**ADDENDUM NO. 1**  
**PARKER SWAMP DRAIN**  
**SAGINAW COUNTY, MICHIGAN**

**RE: CHANGES TO BIDDING DOCUMENTS**

**Parker Swamp Drain  
Mandatory Pre-Bid Conference  
10:00 A.M., May 19<sup>th</sup>, 2022  
Saginaw County Public Works Commissioner**

**PARKER SWAMP DRAIN  
PLAN AND PROFILE  
STA 82+31 TO STA 111+24**

**GLEANER AND PIERCE ROAD  
CROSSING NO. 12 DETAIL**  
SCALE 1" = 10'

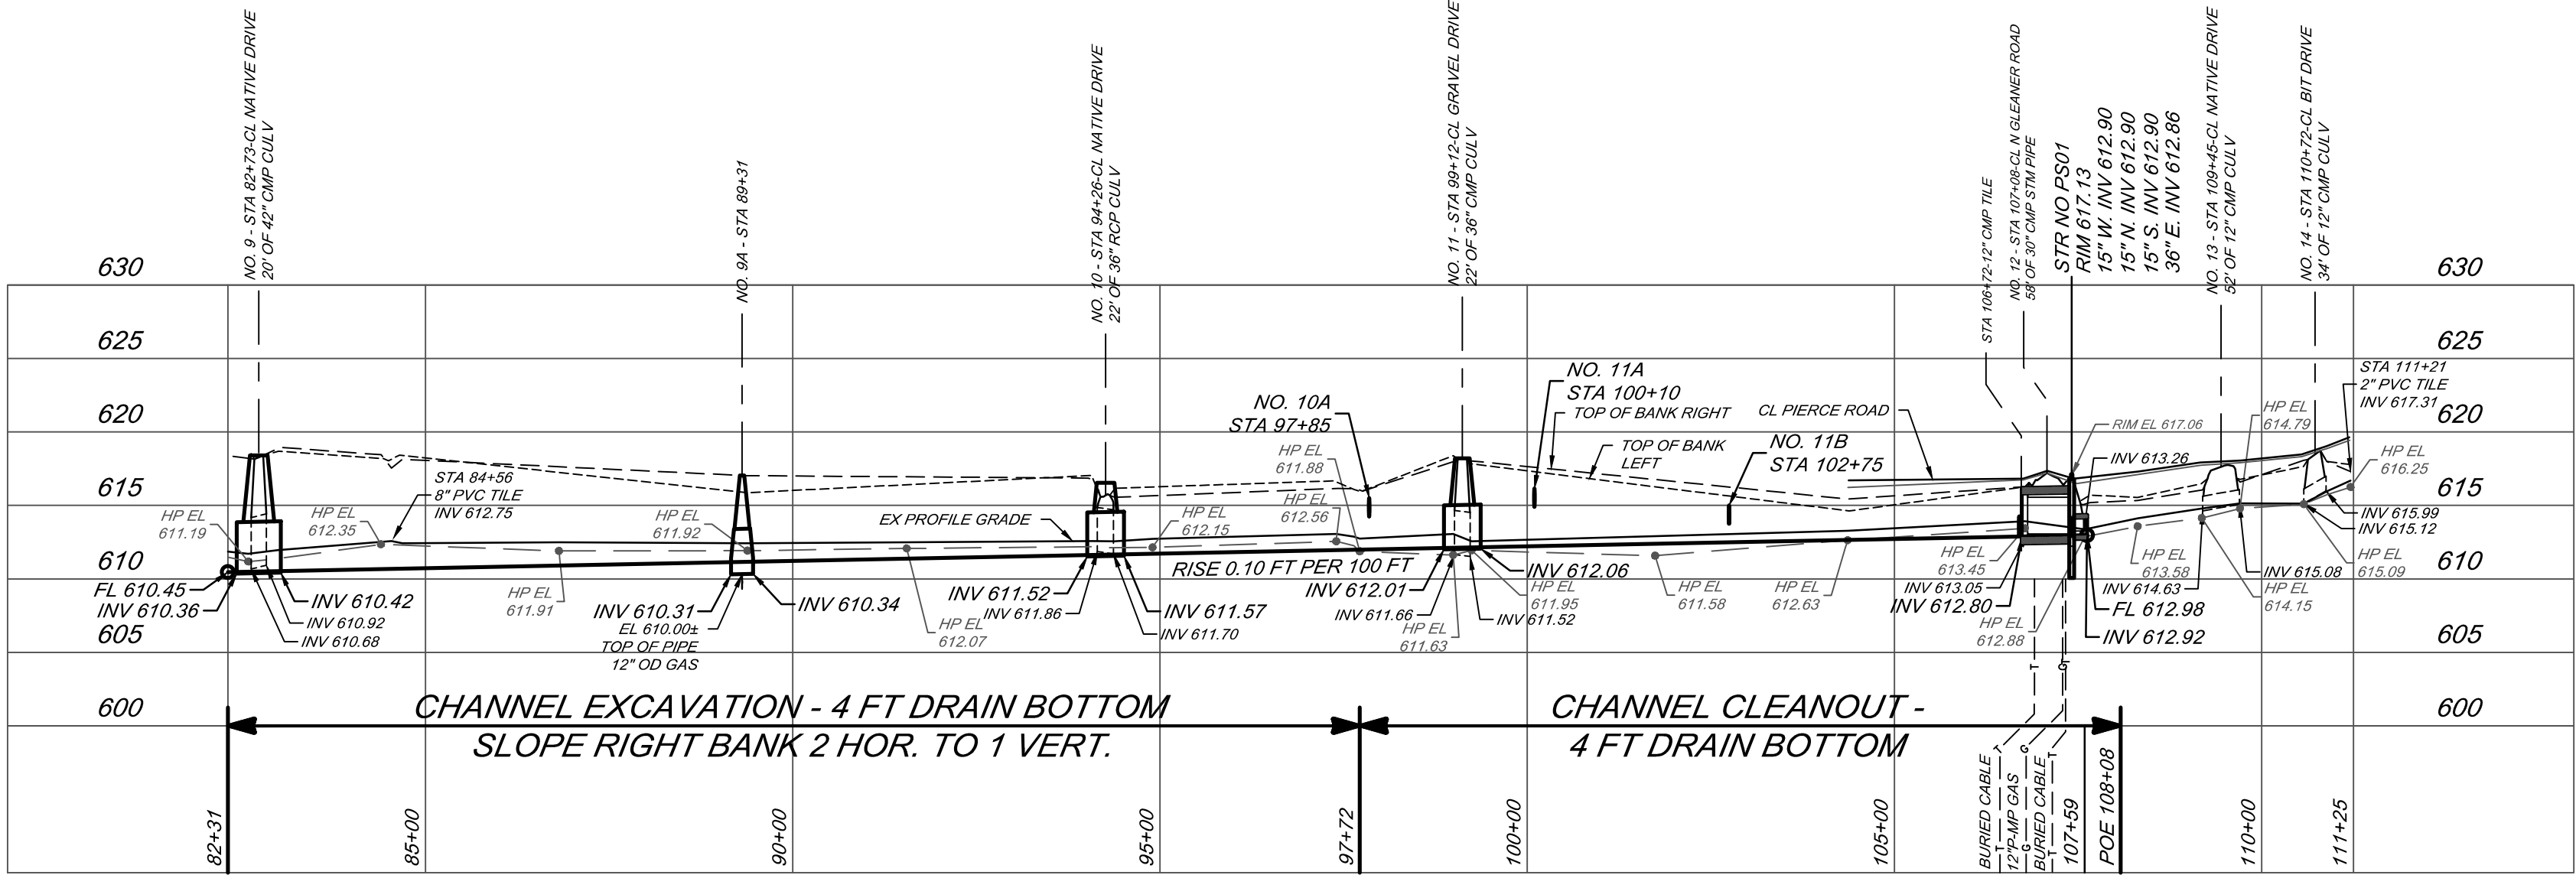
1. Addendum No. 1 has been emailed to you on Monday, May 23<sup>rd</sup>, 2022.
2. Enclosed please find the following attachments pertaining to Addendum No. 1
  - Mandatory Pre-Bid Meeting Minutes
  - Attendance Sheet from Mandatory Pre-Bid Meeting
  - Revised plan sheets:
    - i. DR-4246-06
      1. Updated spoil leveling table
    - ii. DR-4246-08
      1. Added cross culvert and maintenance access culvert to Gleaner and Pierce Road Crossing Detail

- Sta. 39+40 to Sta. 39+80: Remove lower section of fence, install toe of slope riprap
- Sta. 107+00: Additional bid items at intersection of Gleaner Rd and Pierce Rd will be addressed in Addendum No. 1.

***Issue new DR-06 sheet, DR-08 sheet, as well as updated bid form***

NO. 12 - STA 107+08 - NORTH GLEANER ROAD  
REMOVE EXISTING CROSSING, INSTALL PROPOSED  
RCP PER CROSSING NO. 12 DETAIL.  
RESTORE BITUMINOUS ROAD.
